Before the Board of Inquiry
Waterview Connection Project

Memorandum of Counsel on behalf of the **NZ Transport Agency** in relation to the Board of Inquiry's Directions and Schedules dated 6 and 7 May 2011

Dated: 13 May 2011

RESPONSE TO THE BOARD OF INQUIRY'S 7 MAY 2011 SCHEDULE OF WORK REQUIRED ON DRAFT CONDITIONS OF CONSENT AND OTHER DOCUMENTS

Title: **CONSTRUCTION SCHEME PLANS
TE ATATU INTERCHANGE
CONSTRUCTION YARD 1**

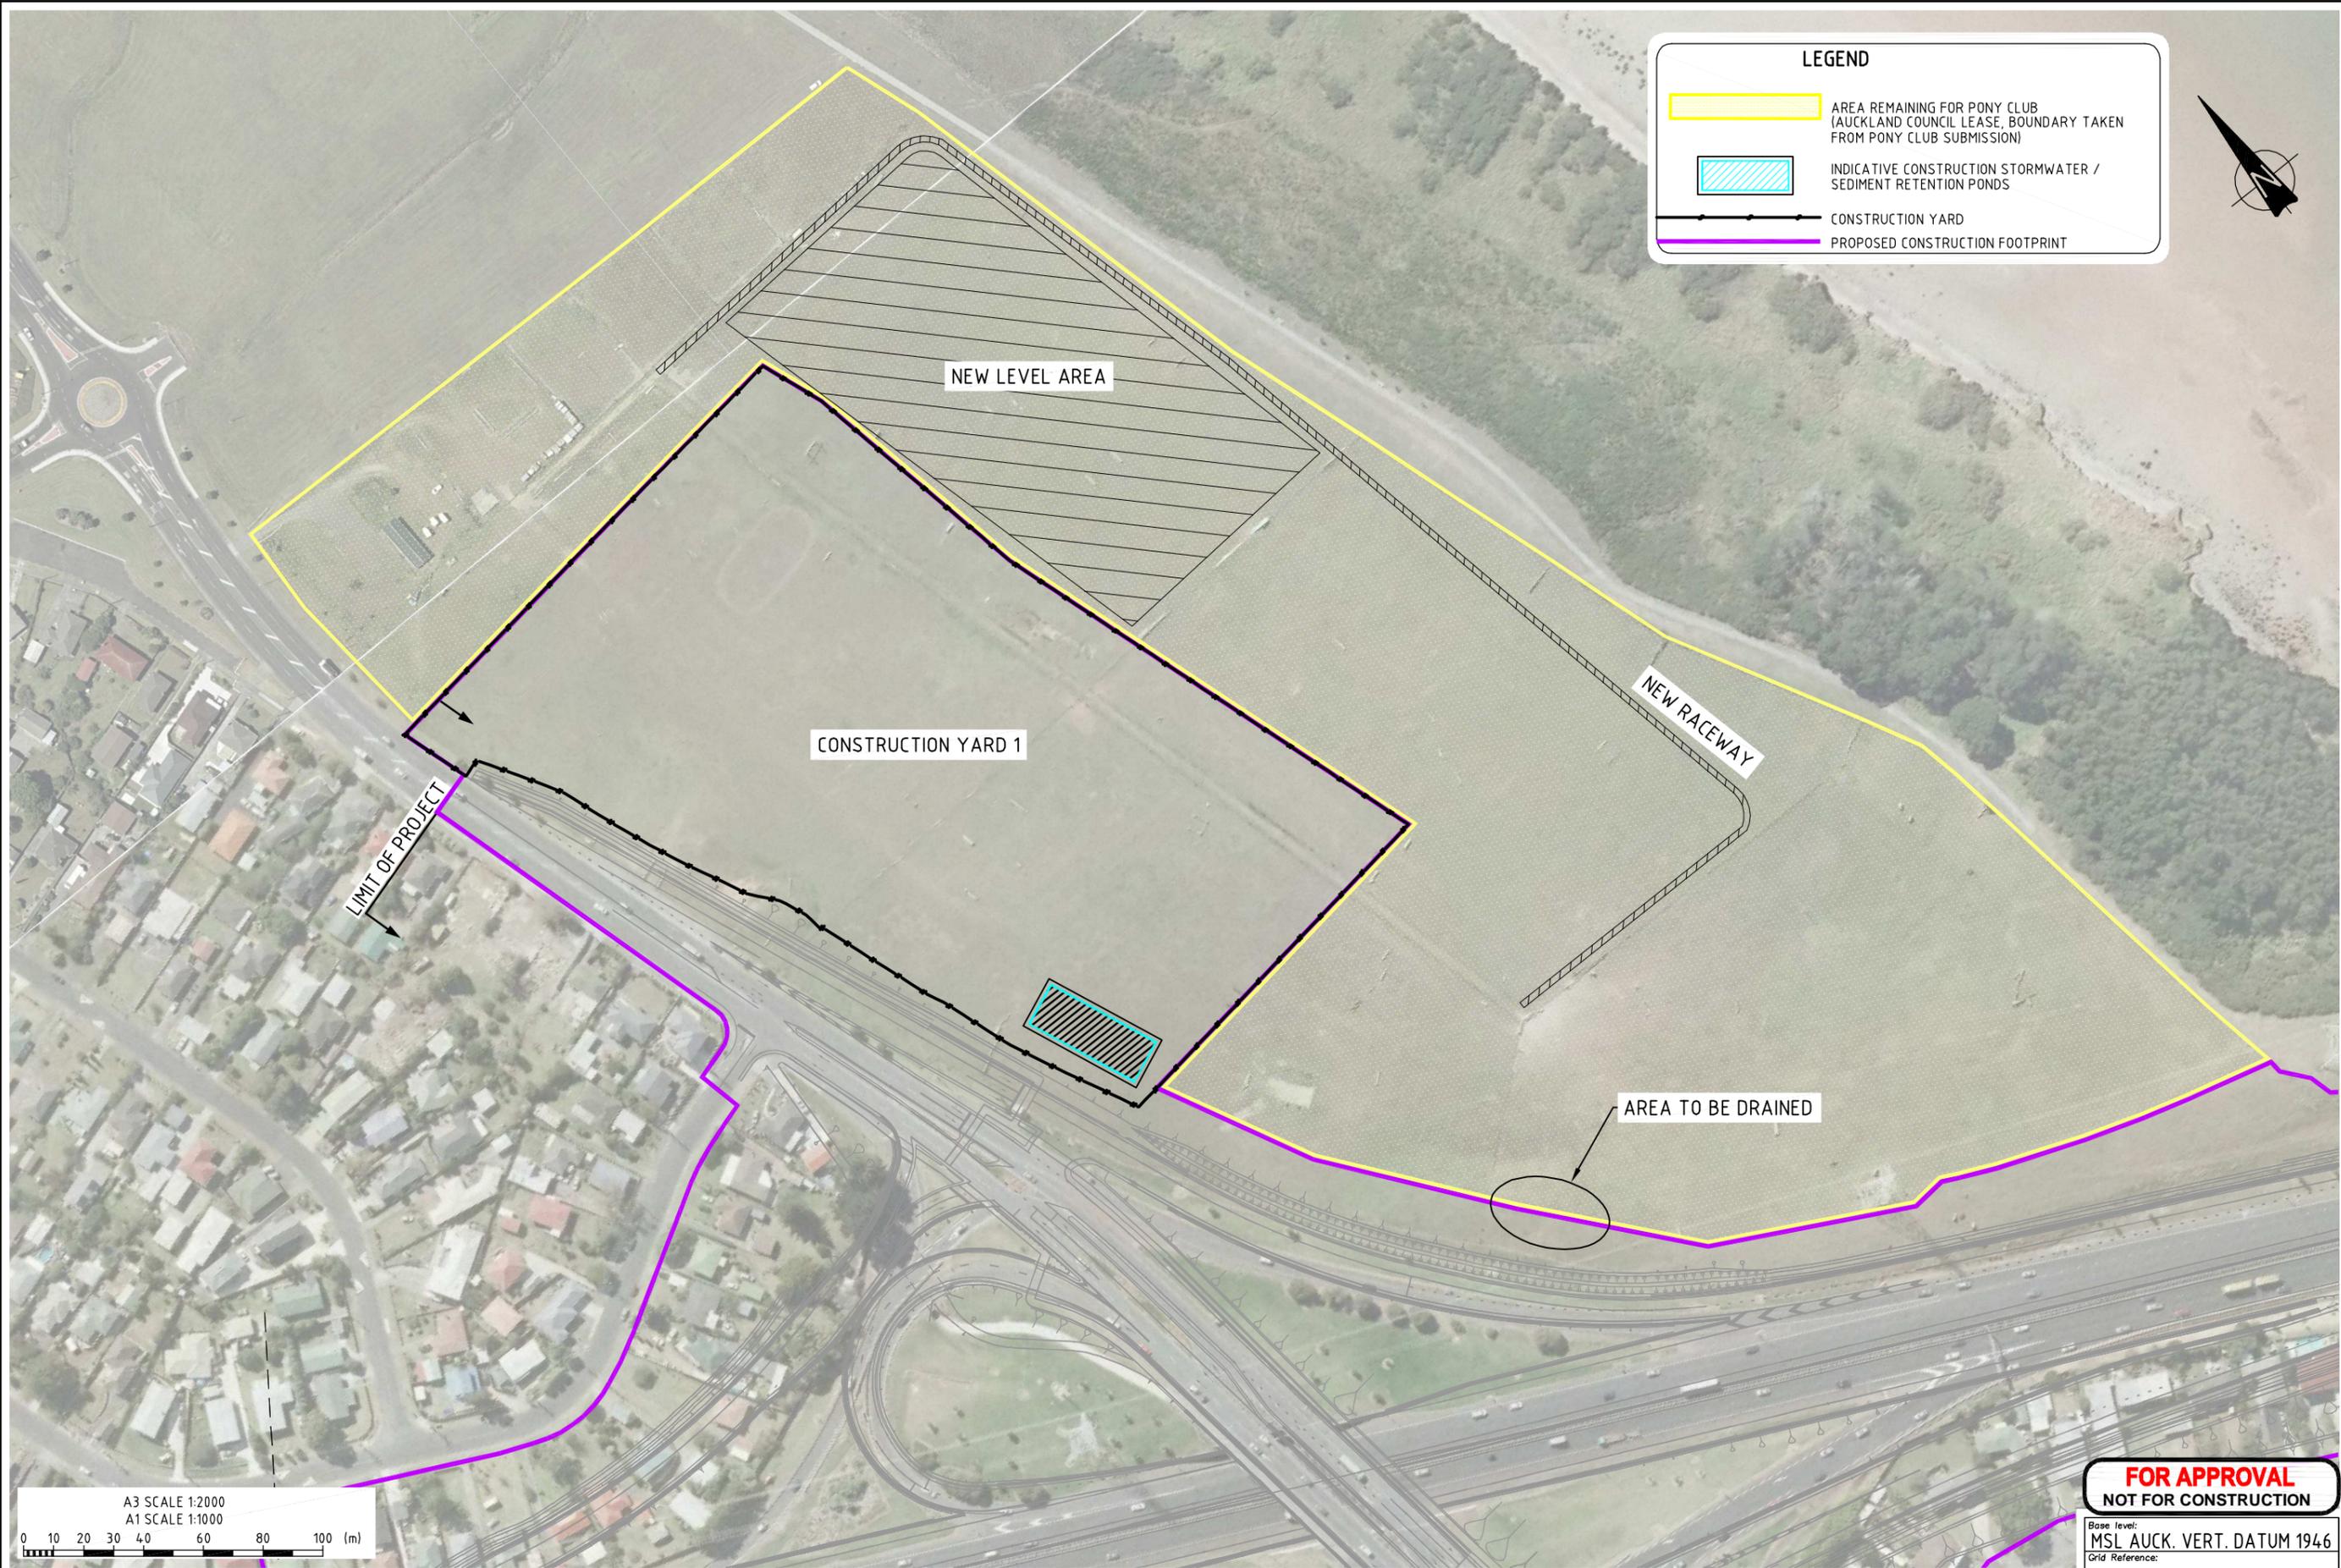
SO.10 – changes made (with correct Drawing name provided). The experts note that this drawing shows an altered designation boundary. Assuming that this altered boundary was confirmed, then some of the works proposed by the NZTA to address Pony Club concerns would be outside the NZTA designation and would likely require consent and landowner (Council) approval. SO.10 and SO.12 have been drafted to reflect this.

A new Construction Yard 1 plan is/has been prepared (formalizing the hand annotations of the Plan provided in the NZTA letter of 21 March 2011) and is submitted to the Board (**see Annexure C**).

Title: **POTENTIAL SH20 TO SH16
 CONCEPT OPTIONS
 FOR CYCLE ROUTE**

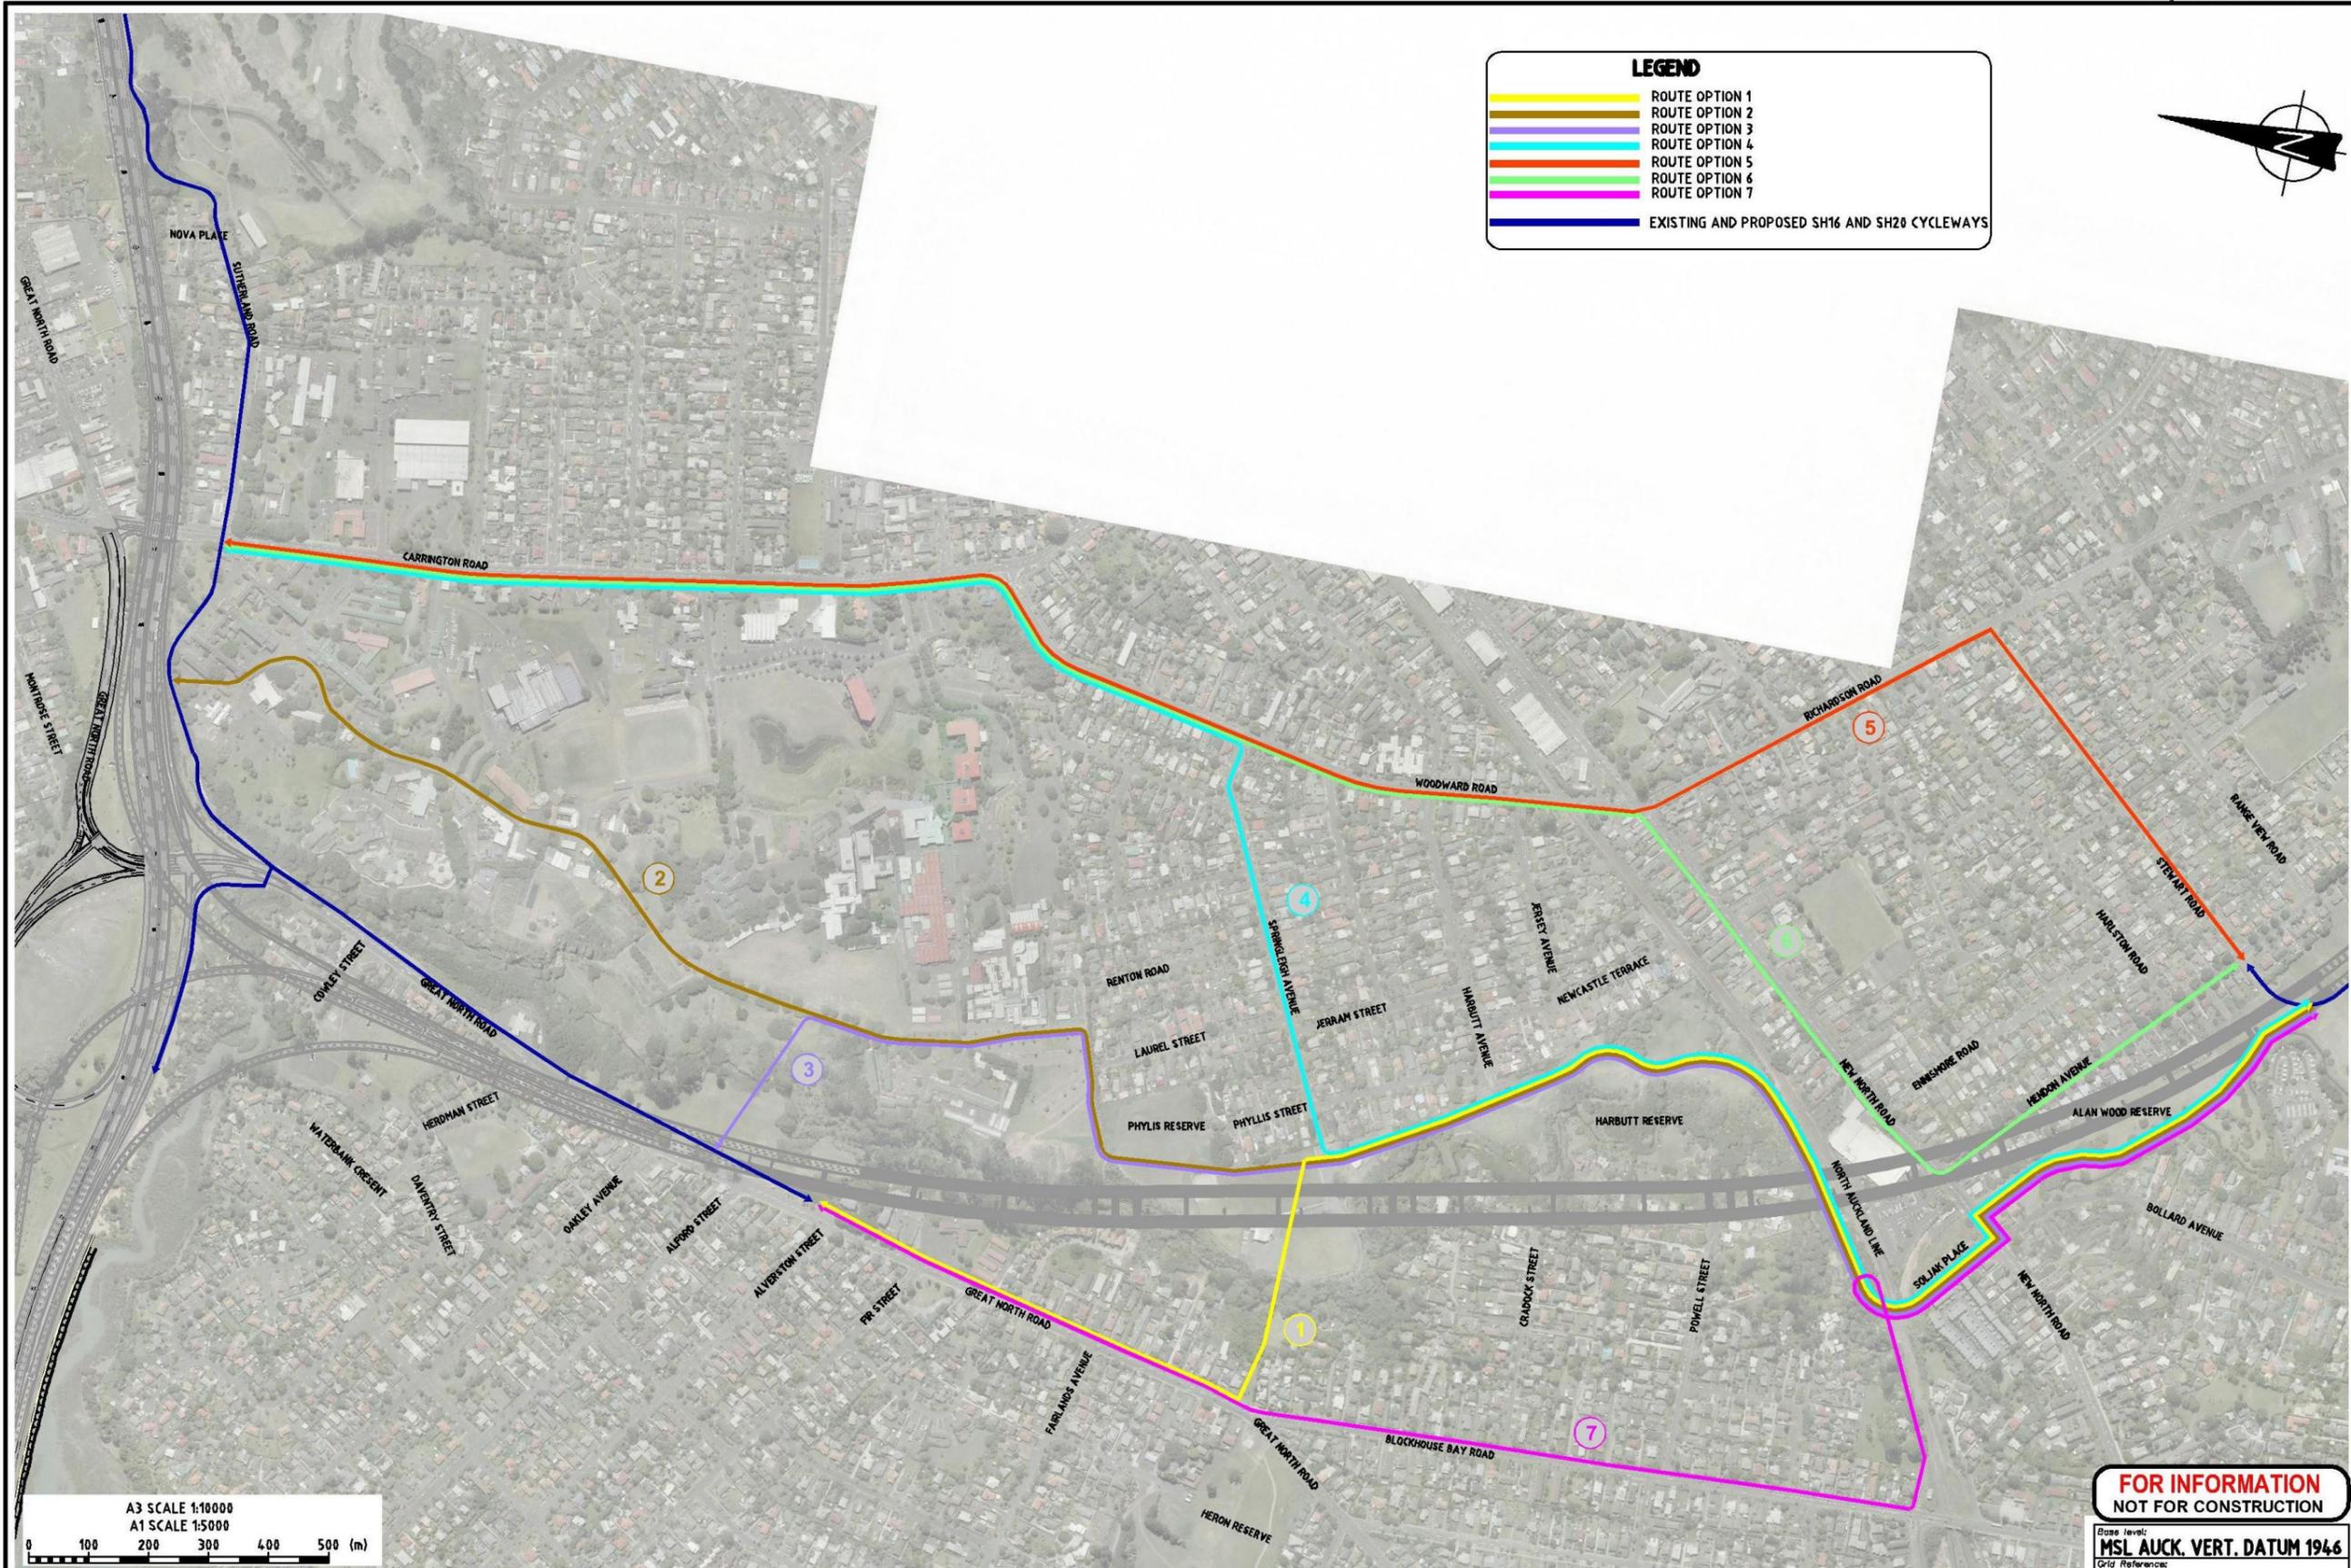
“The NZTA shall provide a financial contribution of \$8 million to Auckland Council to mitigate adverse effects on passive open space and reserves, both during the construction years and longer term, particularly in the Waterview, Owairaka and New Windsor communities. The financial contribution will be used for the construction of a pedestrian and cycleway between Waterview and Owairaka/New Windsor (as generally indicated as Option 3 shown on drawing labelled as "Potential

SH20 – SH16 Concept Options for Cycle Route" (refer to Schedule A, Row 39)),³ the Soljak and Alford bridges and a pathway extension to the Hendon bridge. (The pedestrian and cycleway is in addition to the cycling and pedestrian facilities required by the other conditions.) The financial contribution shall be payable to Auckland Council once the NZTA has received certification from Auckland Council that Auckland Council and Auckland Transport have:

"Construction of a pedestrian and cycleway between Waterview and Owairaka/New Windsor, the Soljak and Alford bridges and a pathway extension to the Hendon bridge (as generally indicated as Option 3 shown on drawing labelled as "Potential SH20 – SH16 Concept Options for Cycle Route" (refer to Schedule A, Row 39) is required to mitigate adverse effects on passive open space and reserves, particularly in the Waterview, Owairaka and New Windsor communities, both during the construction years and longer term. Once the NZTA has received certification from Auckland Council that Auckland Council and Auckland Transport have:

then the NZTA will take all reasonable steps to secure the necessary funding approval under the Land Transport Management Act 2003 for the mitigation works described above and, once funding approval is secured, will transfer \$8 million to Auckland Council forthwith for construction of those works (unless agreed with Auckland Council and Auckland Transport that it shall undertake the works on their behalf.) This condition will have no legal effect from [date].”
